Gary Hunt Investments Pty Ltd  
ACN 627 072 584

CEO  
Douglas Shire Council

Attn: Neil Beck  
Ref: CA 2021\_4239/1 (1028000)

INFORMATION REQUEST  
(Given under Section 12 of the Development Assessment Rules)

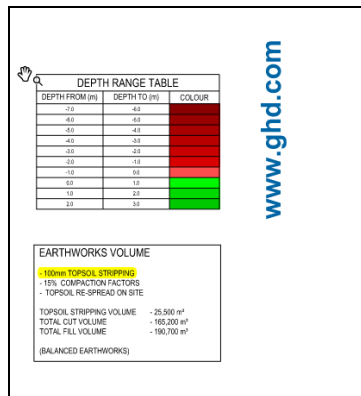
*As part of the response, the applicant is requested to confirm the intended earthworks philosophy for the development and the expected imported fill volume. Advice on the potential sources of fill and the number of truck movements are required to understand potential traffic impacts.*

The comment in section 5.3.4 of the geotechnical report refers to varying depths of "Inferred re-worked ground" based on the summary depths provided above. The majority of this "Inferred re-worked ground" is around 200 mm depth, not 500 mm depth as stated in the RFI and this material was considered when determine earthworks volumes and the cut/fill quantities.

**Figure 2 Proposed intersection upgrade concept layout**

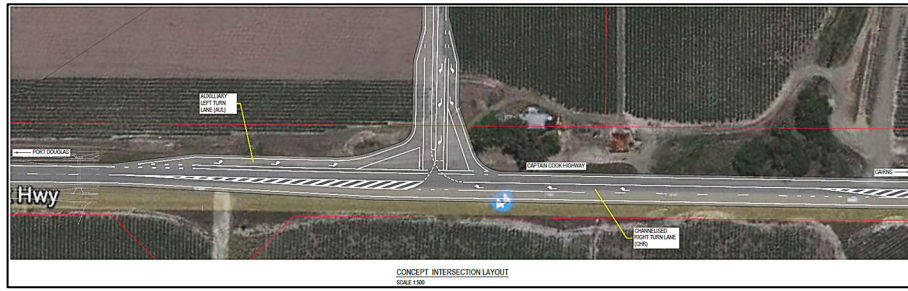
The car parking demands as advised by the applicant requires revisiting. The Applicant is requested to provide a parking assessment on each element of the Resort Complex as required by the parking and access code. Parking arrangements for the Tourist Park is also to be clarified. It is noted the Planning Report advises vehicle access is available to Tourist Park, although the Master Plan Diagrams would suggest otherwise i.e footpath access only. Please clarify.

This proposed intersection provides safety and functionality for CCH traffic and traffic entering and exiting the development. The concept intersection layout is shown in Figure 2 as extracted from the concept sketch.

TITLE		
HYDRAULIC SERVICES MASTER PLAN SANITARY DRAINAGE & WATER SUPPLY		
PROJECT NO.	DRAWING NO.	REVISION
20124	SK01	1

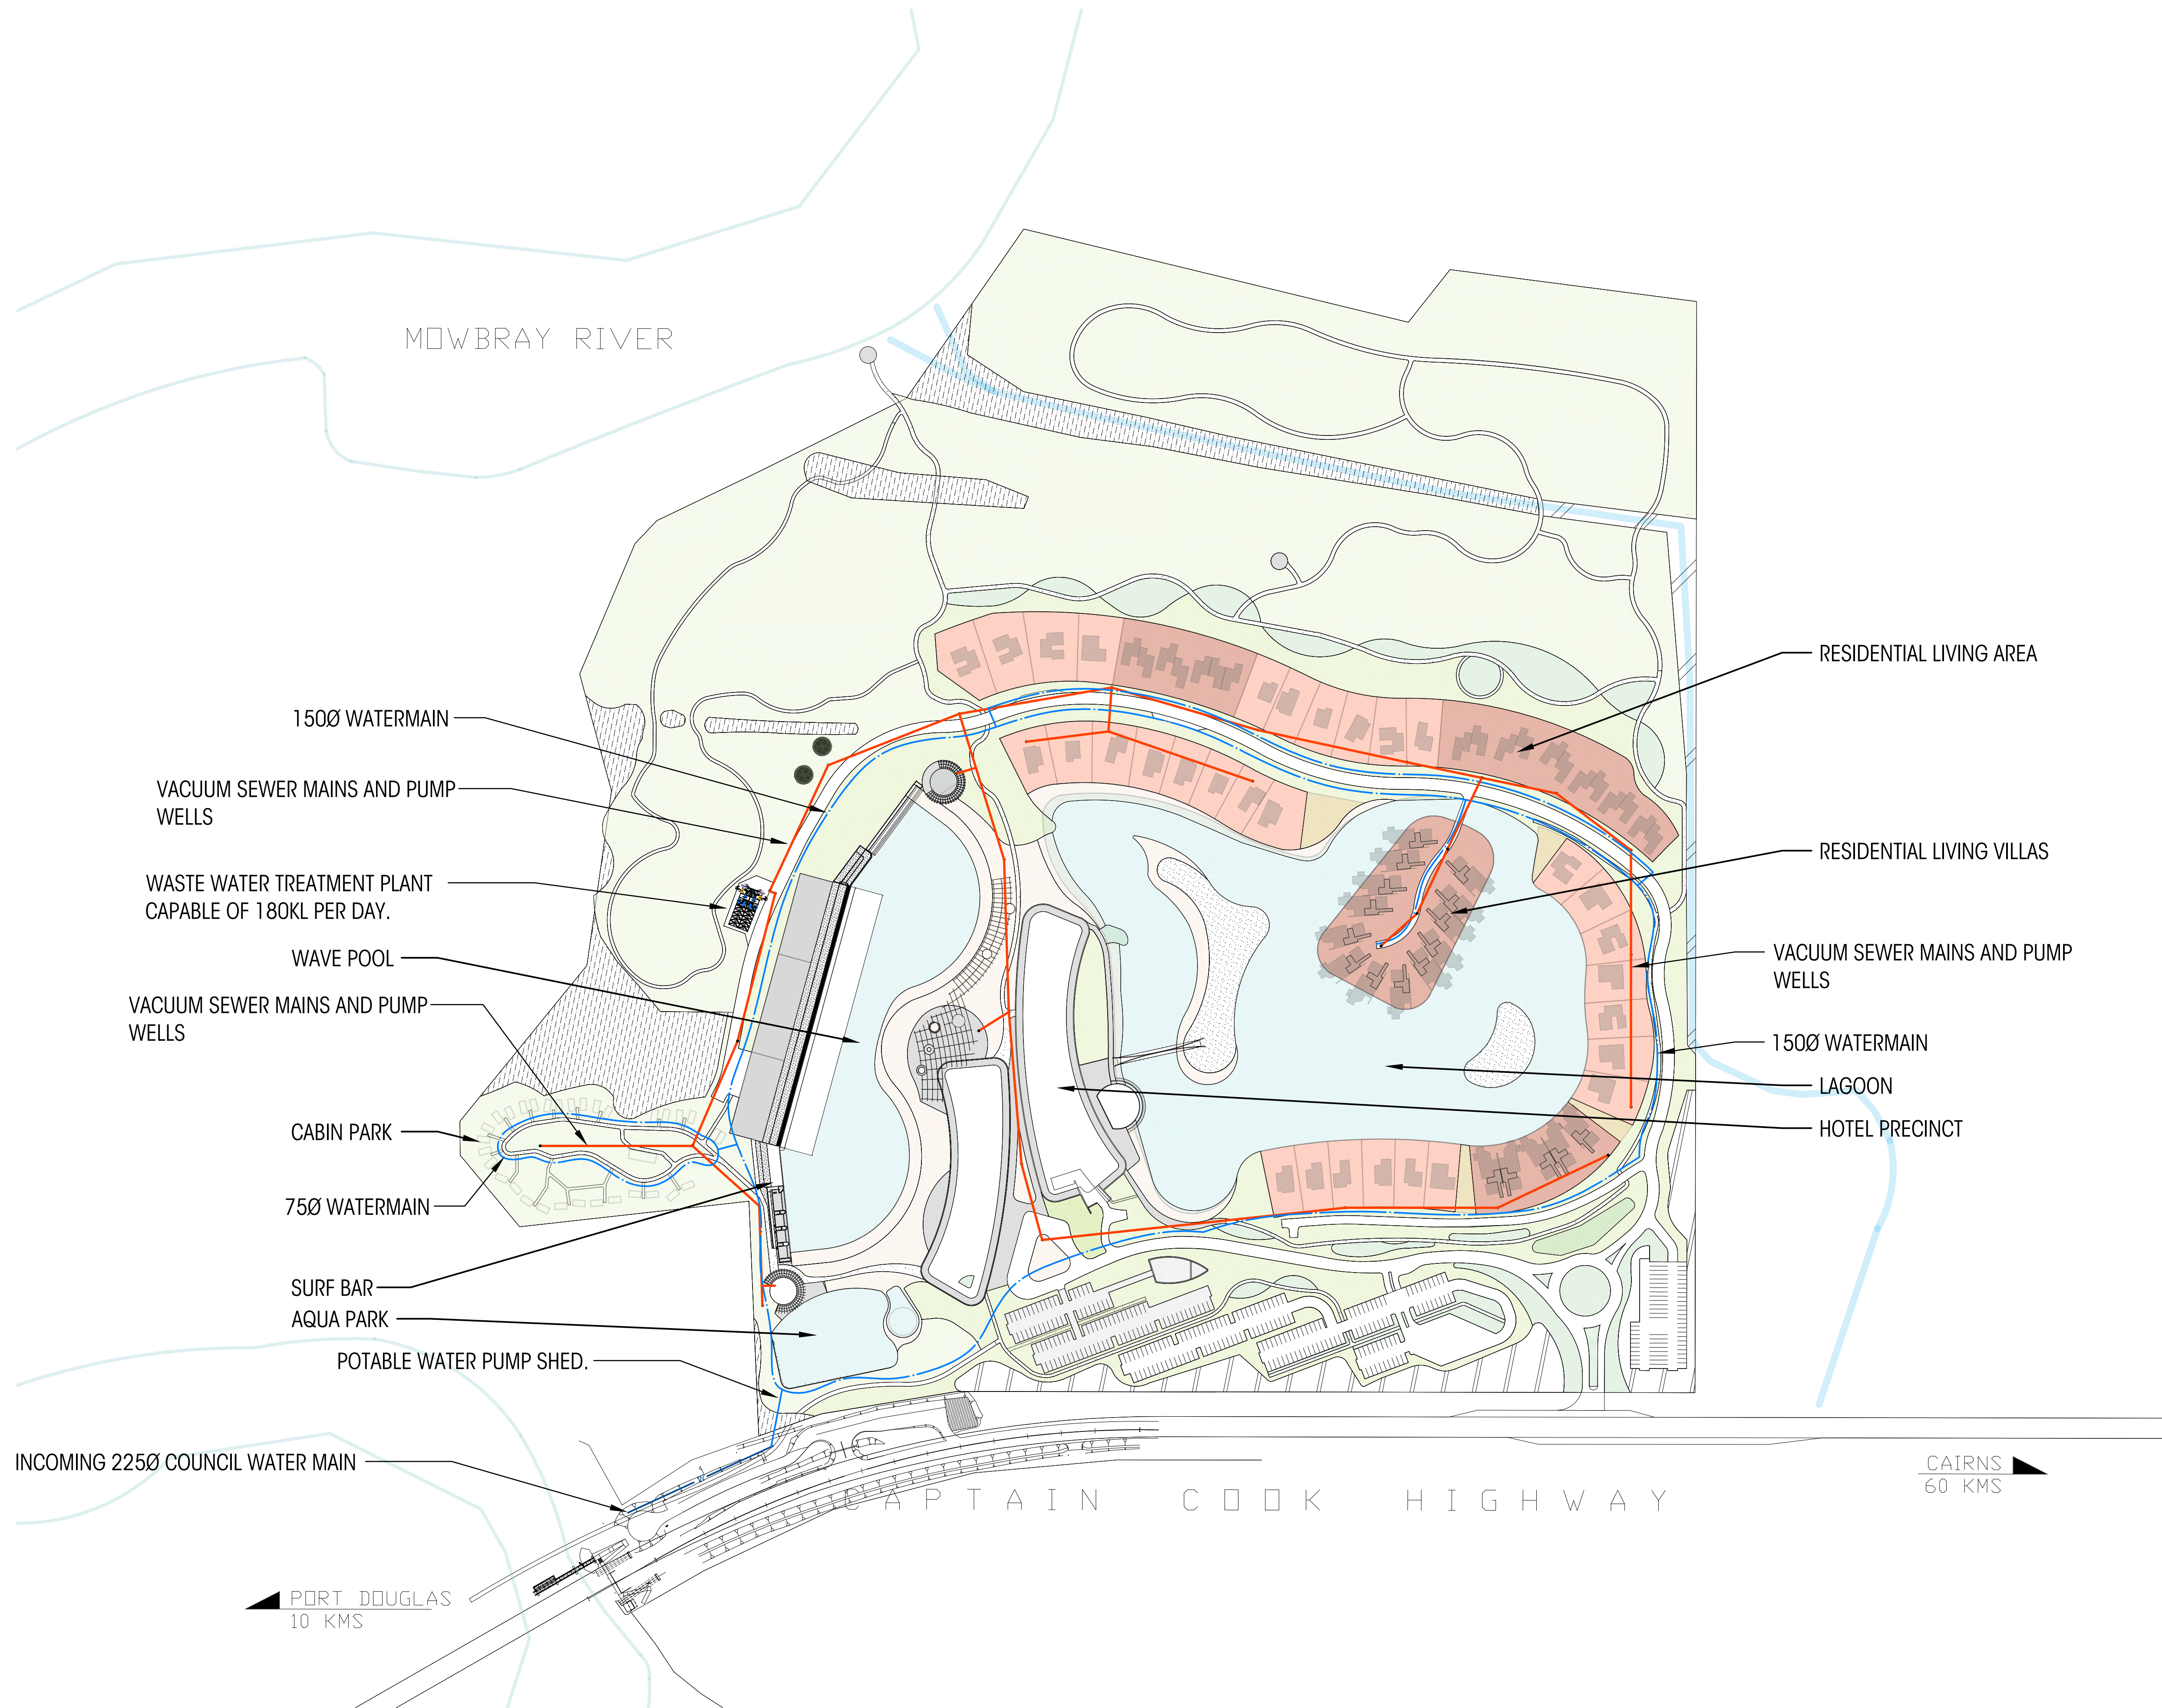
7. Confirm the size of water reticulation mains proposed to connect the site to Council's water supply network having regard to the current constructed infrastructure and the proposed upgrades identified in the Local Government Infrastructure Plan (LGIP). Confirm the increased main sizes required to accommodate the water supply demands for the development and the impact of this on the water reticulation network. It is also noted that the water balance investigation assumed the water storages areas were full for the purpose of the water balance analysis.

SK01 MASTER PLAN – Sanitary Drainage & Water Supply proposes an incoming 225mm diameter main water line to the development. It is requested that further design work be conditioned as part of the permit.
